UNITED STATES PATENT AND TRADEMARK OFFICE

APPLICATION NO.	FILING DATE	FIRST NAMED INVENTOR	ATTORNEY DOCKET NO.	CONFIRMATION NO.
10/614,532	07/07/2003	David H. McFadden	54330/322597	9062

Office Action Summary

DETAILED ACTION

Segment of Fig. 8 of Smith

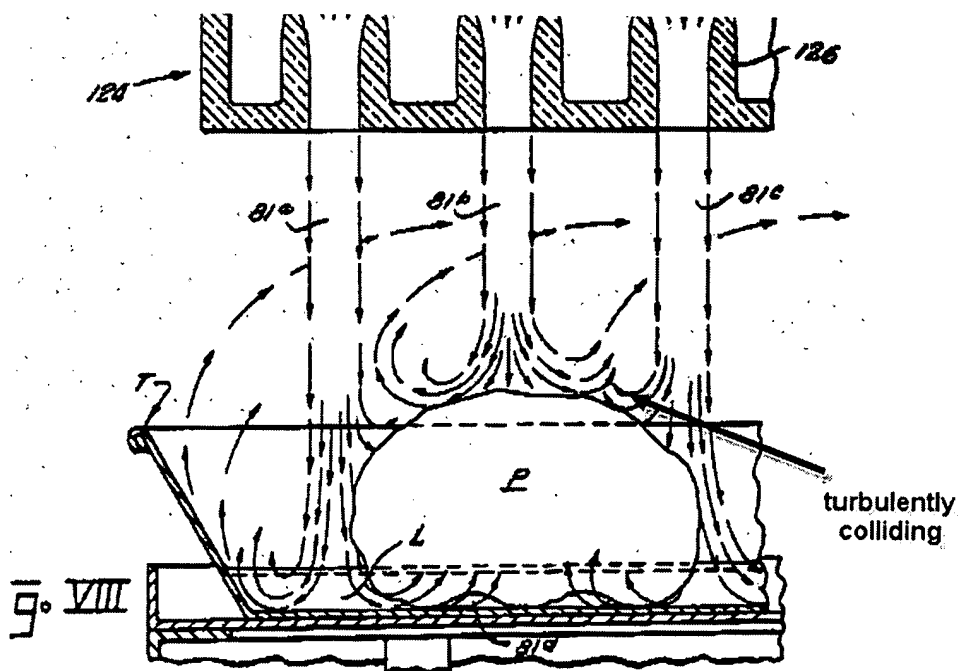
a first means (any one of 80, Figs. 2 and 3 or 124, Fig. 8) for directing gas within the cooking chamber and a second means (any other adjacent nozzle/opening 80, Figs. 2 and 3 or 124, Fig. 8). Each of openings (80 or 124) is disposed above the food product for directing gas above the food product. Gas from the openings is provided in the form of jets (81). As shown particular in Fig. 8, a first gas jet (81b) and a second gas jet (81c) are provided to strike a food product (P) and are considered to collide turbulently in close proximity to a surface of the food product to desirable enable "very rapid heat transfer and very rapid water vapor removal from the surface of the product" (see col. 10, lines 45-51). The following is a segment of Fig. 8 of Smith to further illustrate what the examiner considered to be "turbulently colliding" gas flows:

(examiner has added arrow and text)

Further, the examiner notes that Smith expressly notes that jets (81) when striking a solid surface will be transformed into a “turbulent mushroom shaped pressure area” (see col. 11, lines 6-11).

While this discussion is in the context of the jets striking the bottom of the food product, the examiner considers that a person of ordinary skill in the art would recognize that the “turbulent mushroom shaped pressure area” would also result on the top of the food product (as shown for instance in Fig. 8 of Smith).

In regard to claim 98, at least Fig. 8 of Smith suggests multiple impingement points of the air and food product causing “simultaneously colliding the gas at multiple locations about the selected surfaces of the food product as recited” (see at least col. 10, lines 45-56).
